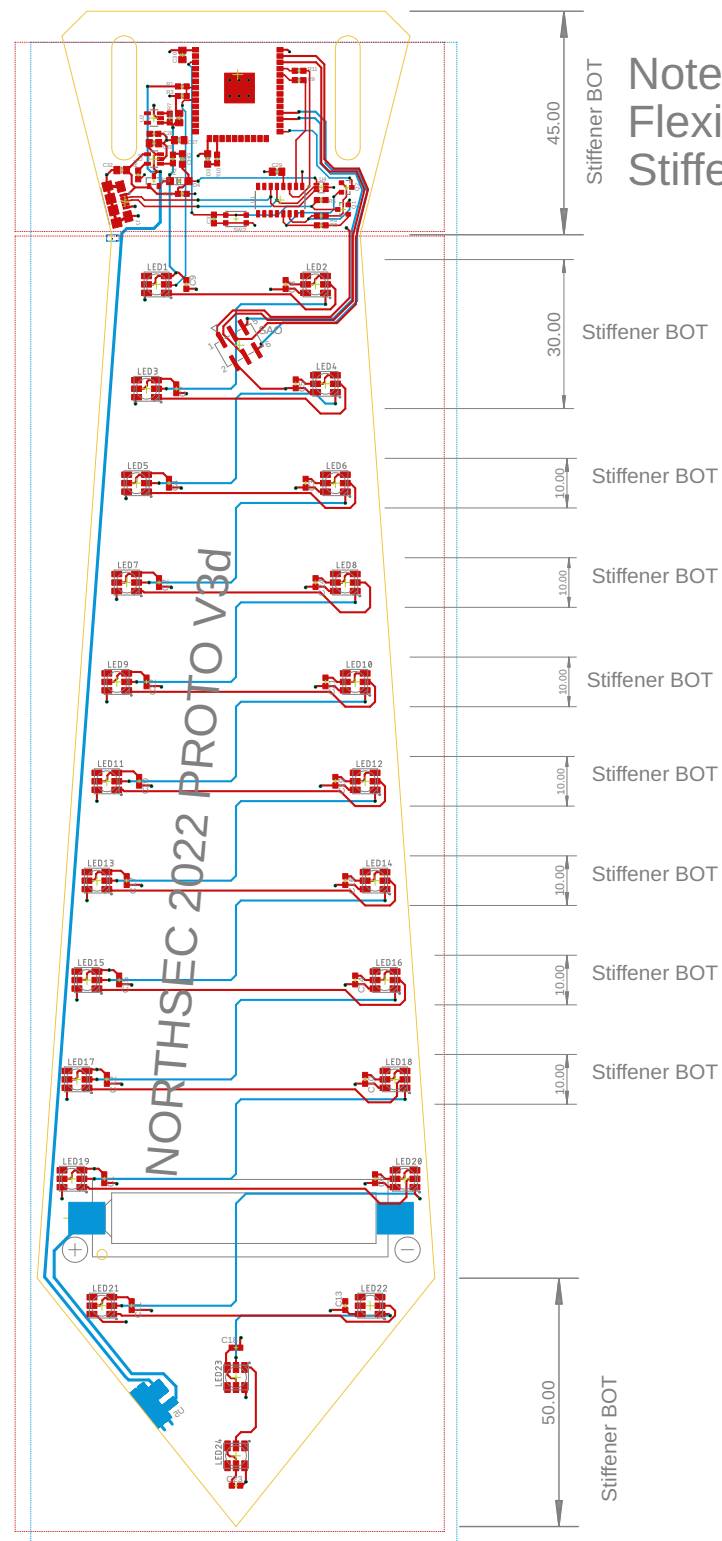
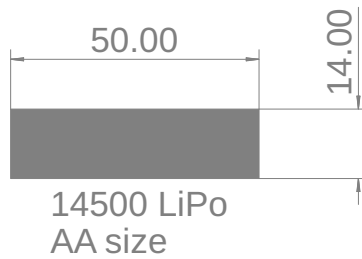
- trace right of LED20 moved to allow ground pour
- adjusted spacing GPIO0, SDA, SCL
- adjusted VBAT trace going to R1
- adjusted VDD on R7 & C25
- moved battery up by a few mm
- changed the stiffner under the SAO conn
